Specification Mintech./CV6178; CV6192; CV6206	<u>SECURITY</u>
Issue 1A, Dated April 1968	<u>Specification</u> <u>Valve</u>
To be read in conjunction with K1001 and BS1409.	Unclassified Unclassified

SPECIFICATION Mintech/CV6178; CV6192; CV6206. Issue 1A, Dated April 1968

AMENDMENT No. 1

OUTLINE DRAWINGDIMENSIONS

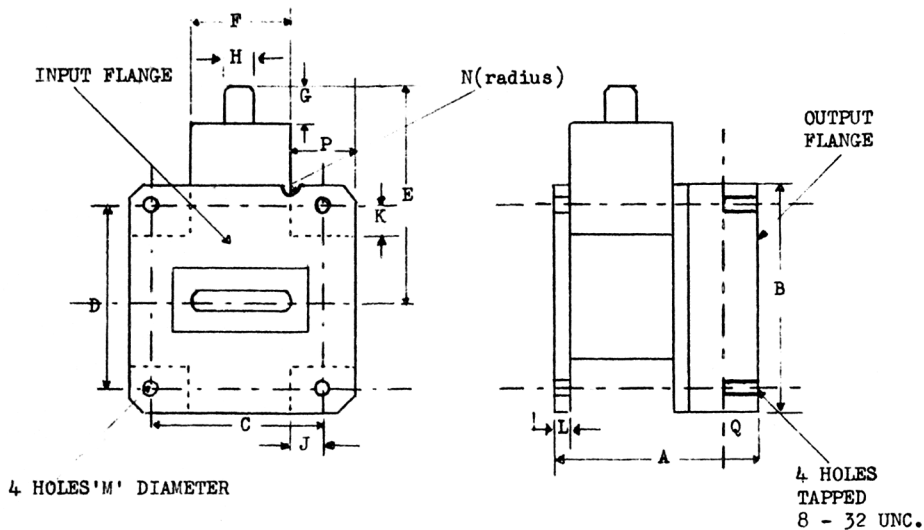
Page 5 Outline Drawing:

In the table of dimensions, amend the following dimensions as appropriate:-

'B' - amend to read " $1.625 \pm \frac{1}{64}$ "

'E' - amend to read "1.625 max."

'F' - amend to read "0.78 max."

'H' - amend to read "0.25 min."

'J' - amend to read " $\frac{7}{32}$ min."

'K' - amend to read " $\frac{3}{16}$ min."
